ADDENDUM 1

REF: Bid 2022-09 Portable Classroom Improvements at Five Schools

The following changes are made a part of the Drawings and Specifications for the project named above. Receipt of this Addendum is to be acknowledged in the space provided on the Bid Form. Failure to do so may subject the Bid to be considered as non-responsive.

MINOR SITE PLAN NORTH HAGERSTOWN HIGH SCHOOL **PORTABLE CLASSROOM BUILDINGS** SITUATE AT 1200 PENNSYLVANIA AVENUE CITY OF HAGERSTOWN, WASHINGTON COUNTY, MARYLAND

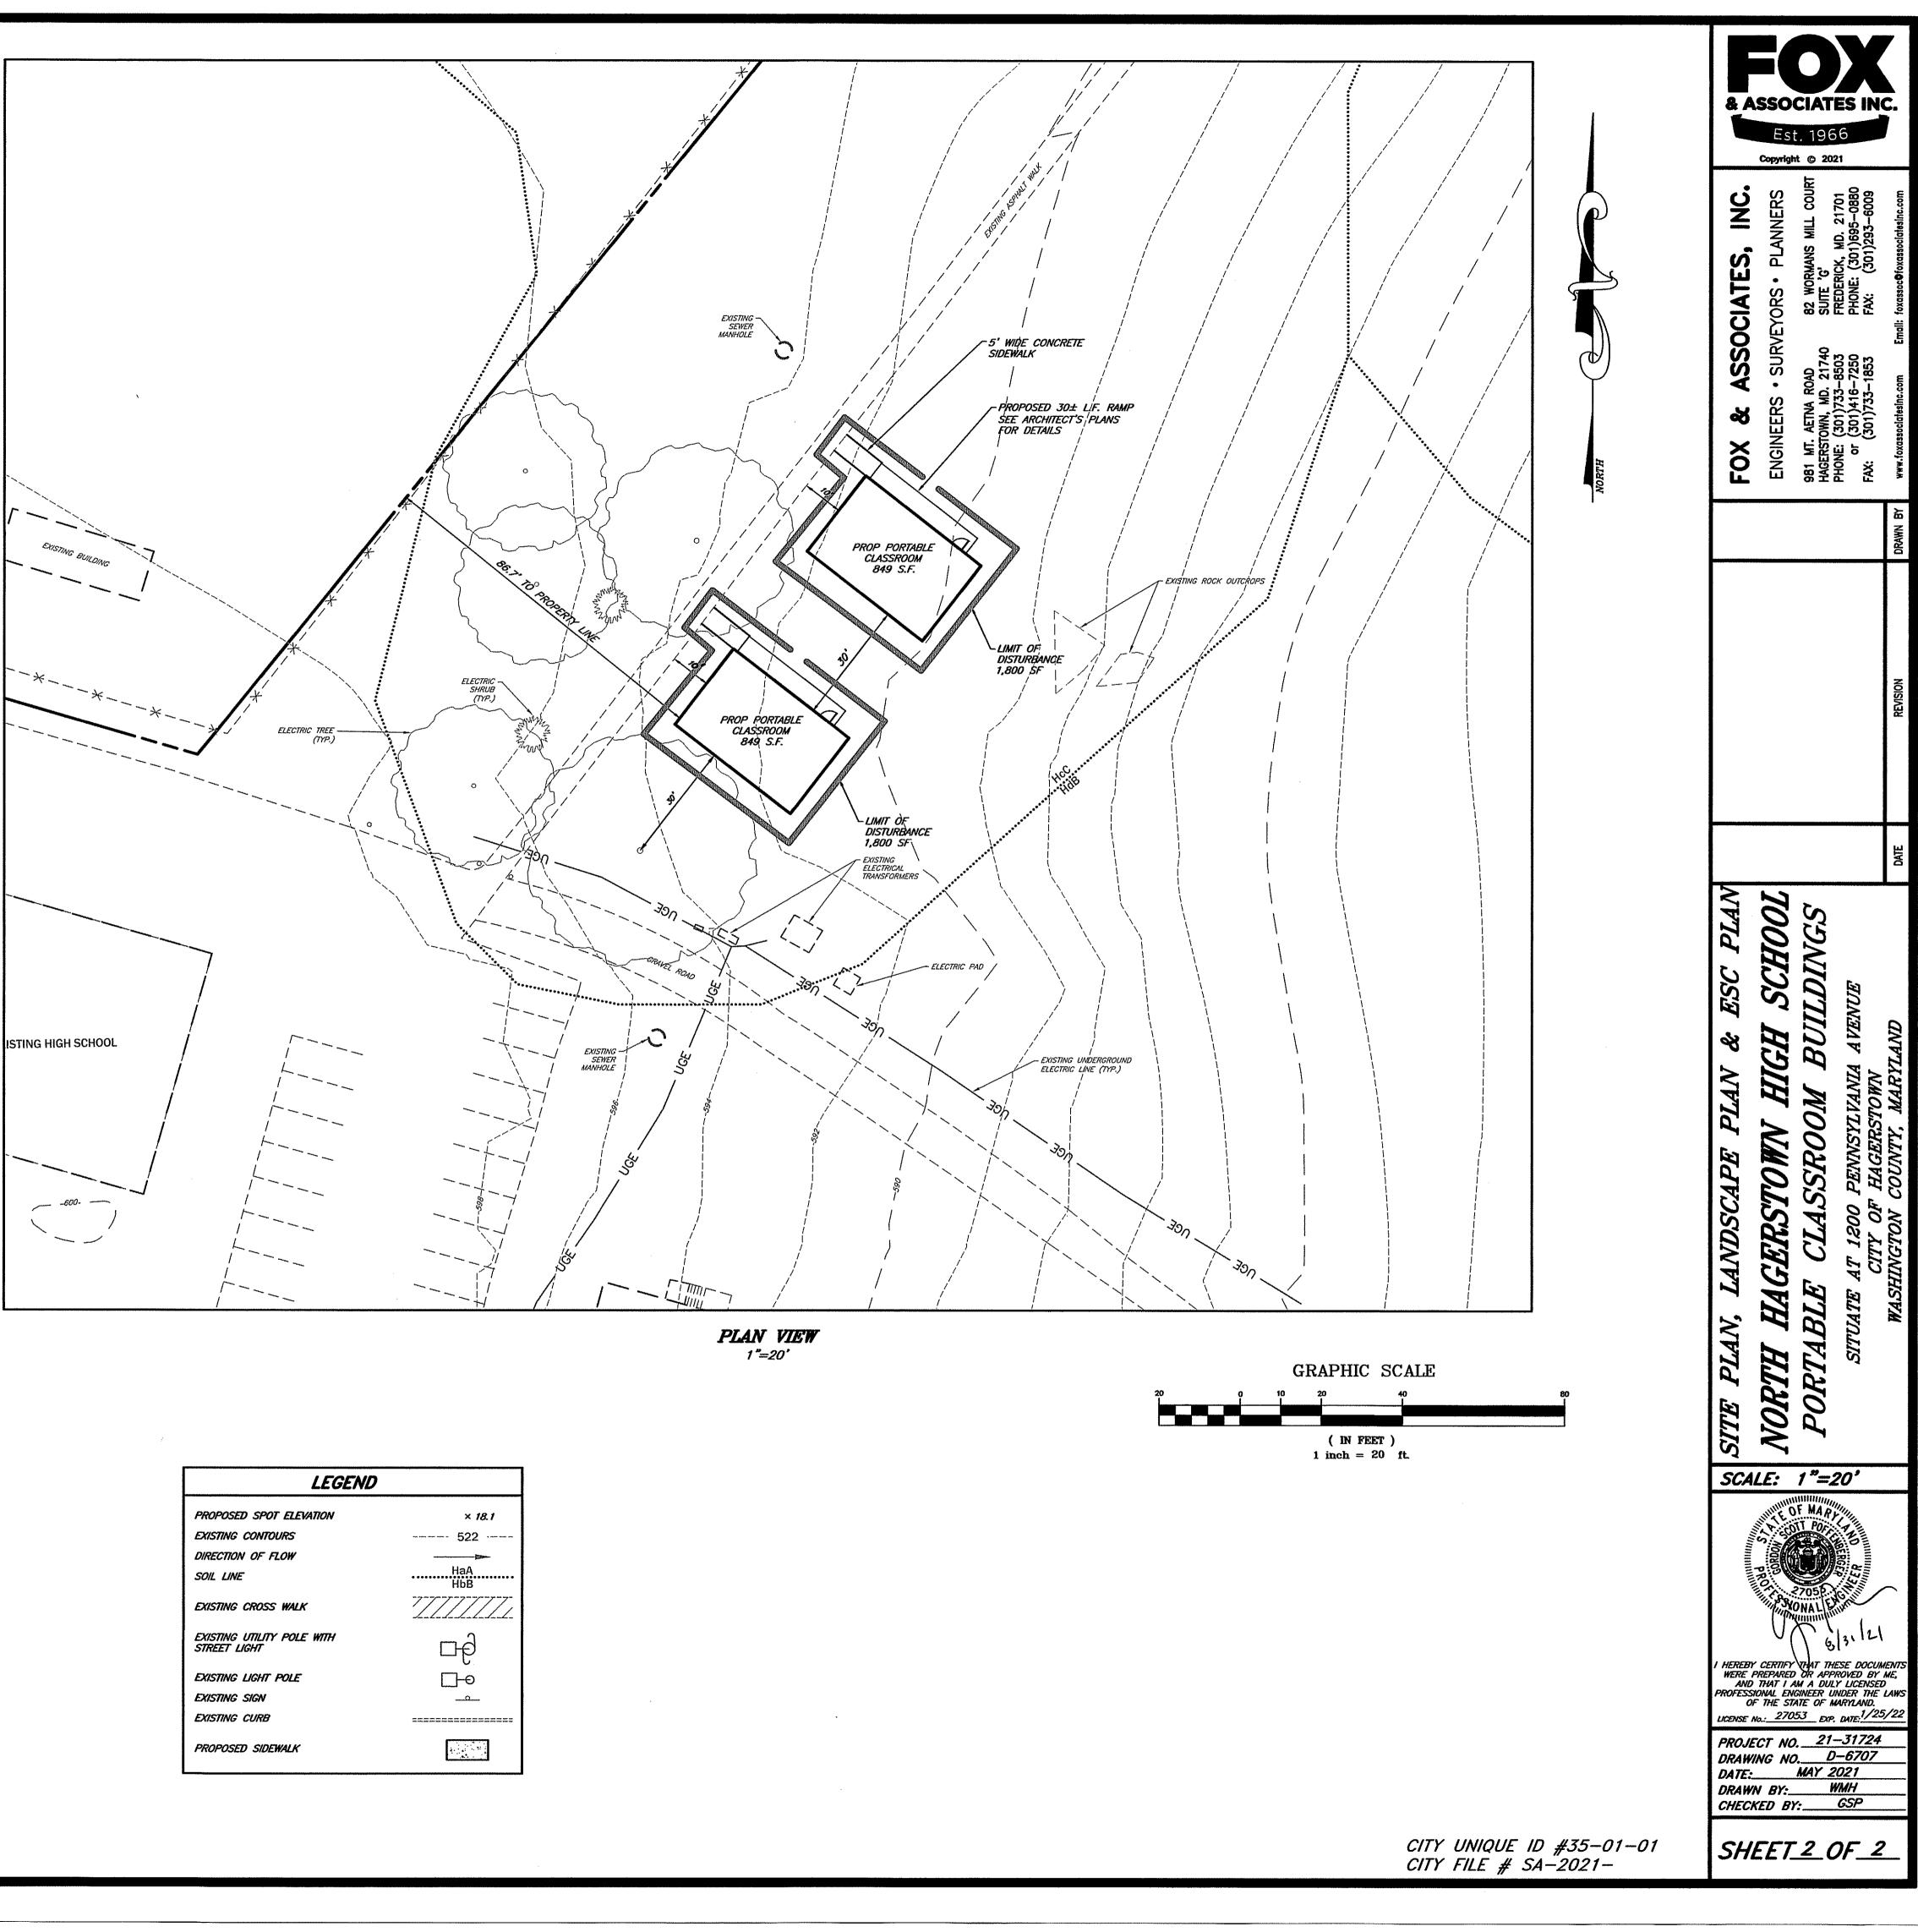
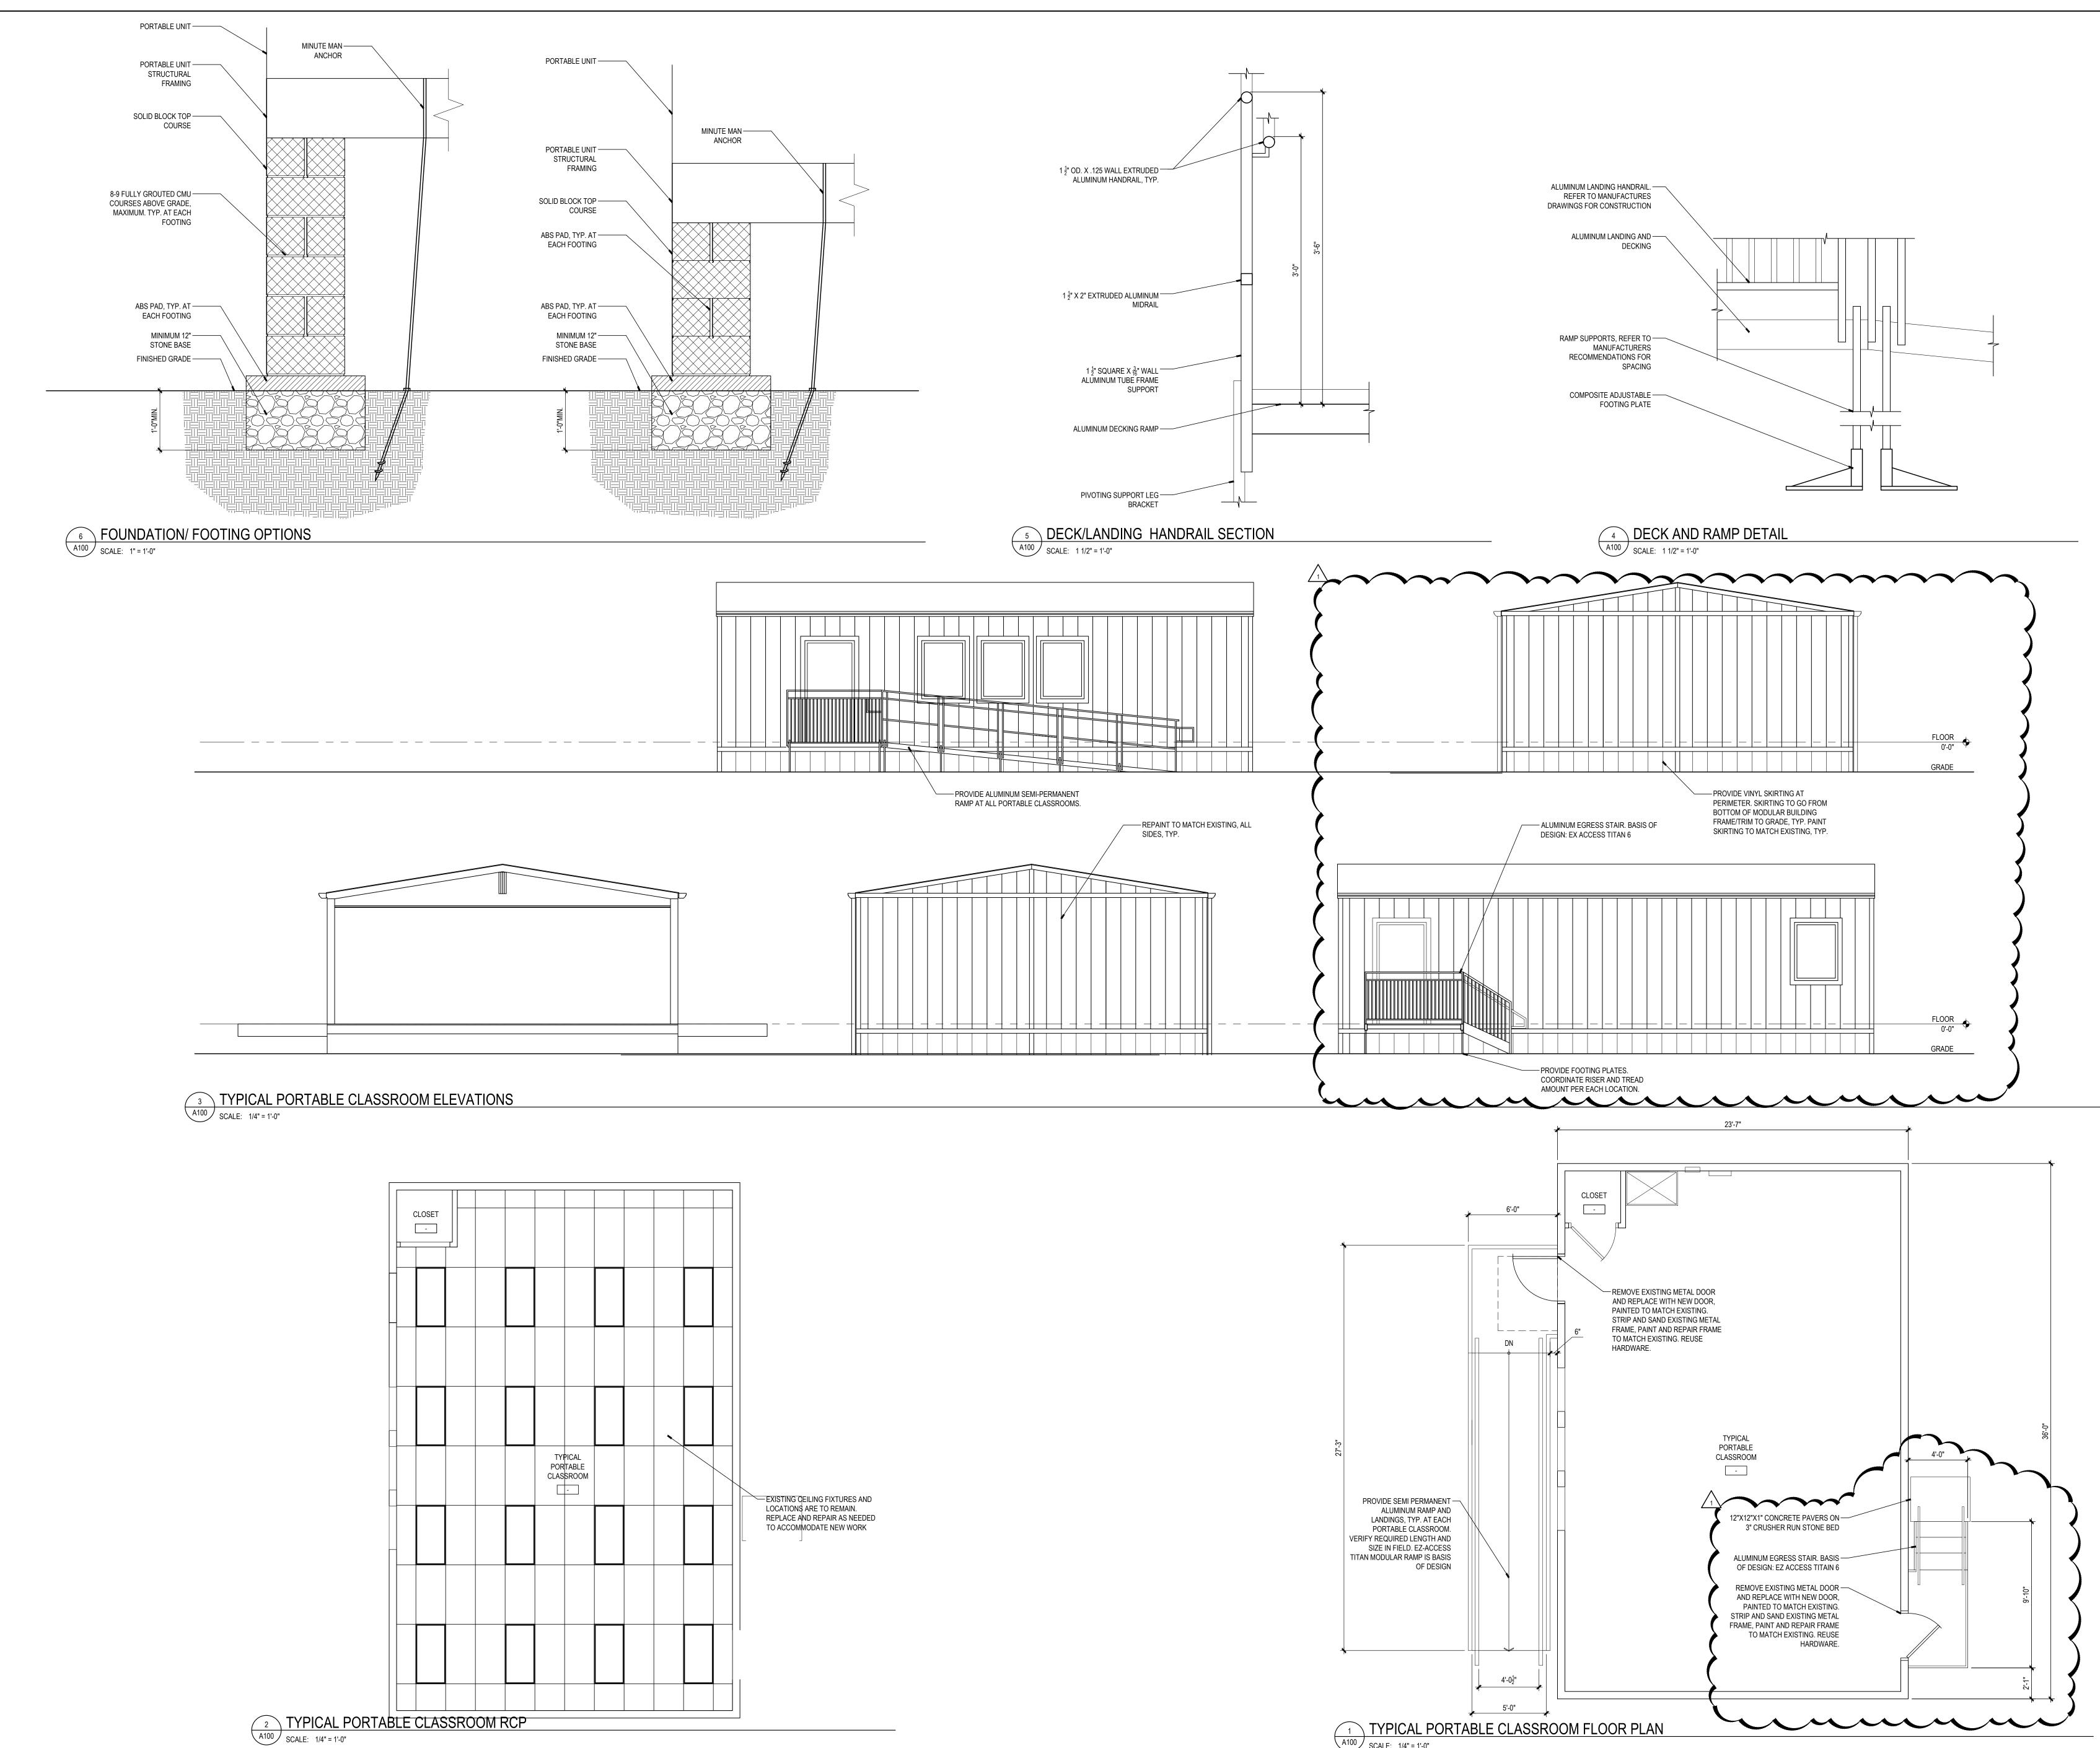
- 1.27 **DELETE** E302 and **REPLACE** with revised E302 attached to this addendum. Note that the incorrect portable classroom location is shown on this drawing. Bidders shall assume that new portables are 200 feet away from the plan northwest corner of NHHS, and shall route all utilities to the new location as shown on the sheets referenced in Addendum item 1.24.
- 1.28 **DELETE** E303 and **REPLACE** with revised E303 attached to this addendum.
- 1.29 **DELETE** E304 and **REPLACE** with revised E304 attached to this addendum.
- 1.30 **DELETE** E305 and **REPLACE** with revised E305 attached to this addendum.

DATE: REVISION: REVISED LOCATION OF PORTABLE CLASSROOMS 8/31/21
